KP-NRC-2512-001

**Approved Version of KP-FHR Core Design and Analysis Methodology Topical Report
(Non-Proprietary)**

SUBJECT: KAIROS POWER LLC – FINAL SAFETY EVALUATION OF TOPICAL REPORT,
“KP-FHR CORE DESIGN AND ANALYSIS METHODOLOGY,” REVISION 1
(EPID NO: L-2024-TOP-0013)

**KAIROS POWER LLC – FINAL SAFETY EVALUATION OF TOPICAL REPORT
KP-TR-024-P, “KP-FHR CORE DESIGN AND ANALYSIS METHODOLOGY”
(EPID L-2024-TOP-0013)**

Figure 3-1 Core Modeling Domains

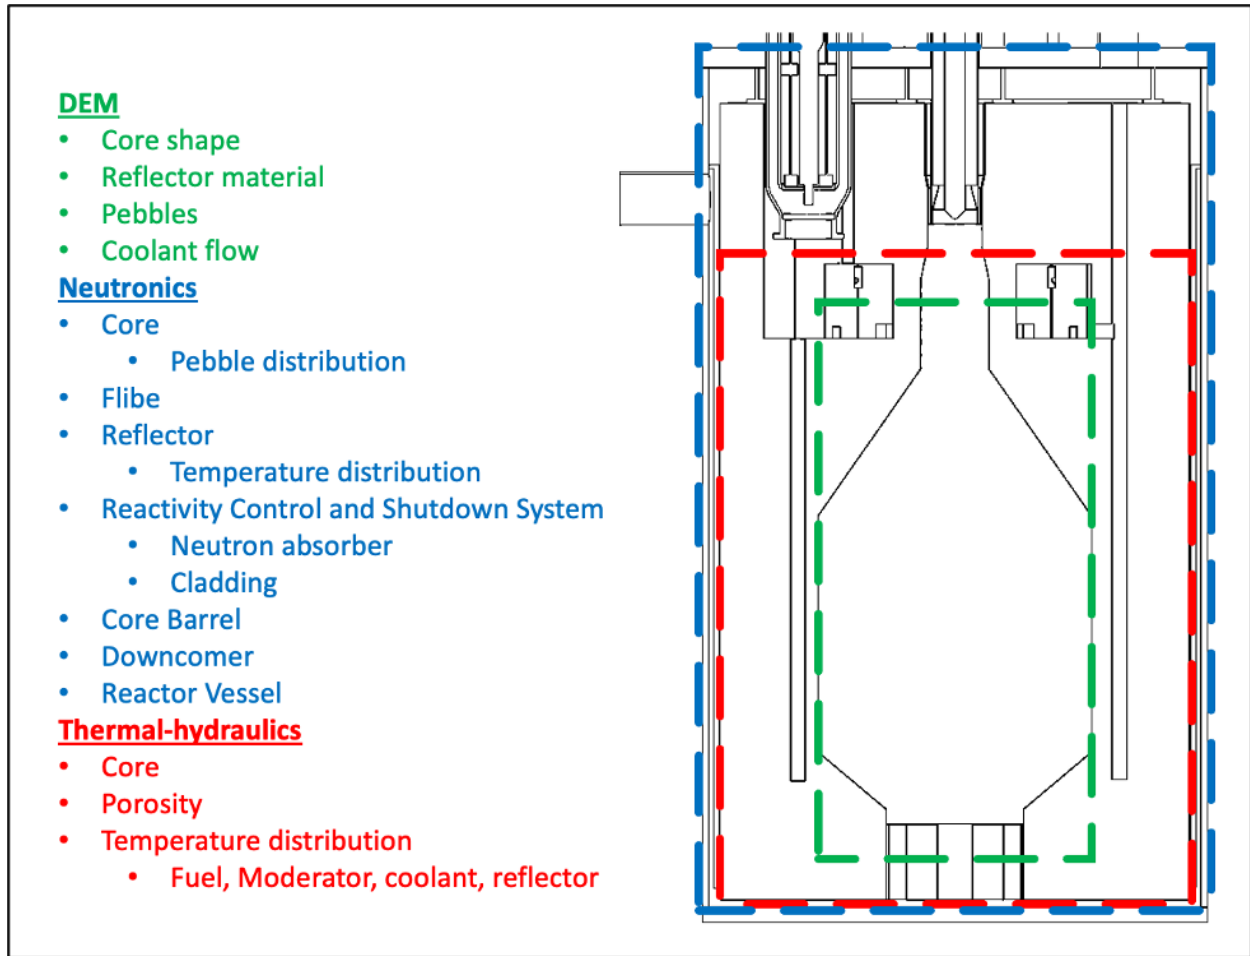
The Kairos core design and analysis methodology consists of three models (paradigms): DEM, thermal hydraulics, and neutronics. The modeling domain for each model is shown in figure 3-1,

The neutronic model calculations are performed using Serpent 2, a continuous-energy Monte Carlo (MC) neutron transport code. As shown in TR figure 3-1, the modeling domain for the neutronic model includes a full three-dimensional (3-D) representation of the core (including converging and diverging sections), defueling chute, fueling region, reactor shutdown system (RSS), reactor control system (RCS), graphite reflector, reactor penetrations, core barrel, downcomer, and reactor vessel. The core model explicitly represents different types of pebbles and tri-structural isotropic (TRISO) particles. The reflector is modeled with major engineered penetrations and geometries for the coolant paths. The neutronic model is explicitly coupled with the thermal-hydraulic model using the KPATH wrapper code. The power distribution calculated by the neutronic model is provided as input to the thermal-hydraulic model. The material temperature distributions calculated by the thermal-hydraulic model are used to update the material cross-sections in the neutronic model. The NRC staff’s evaluation of the neutronic model is provided in SE section 2.3, “Neutronics.”
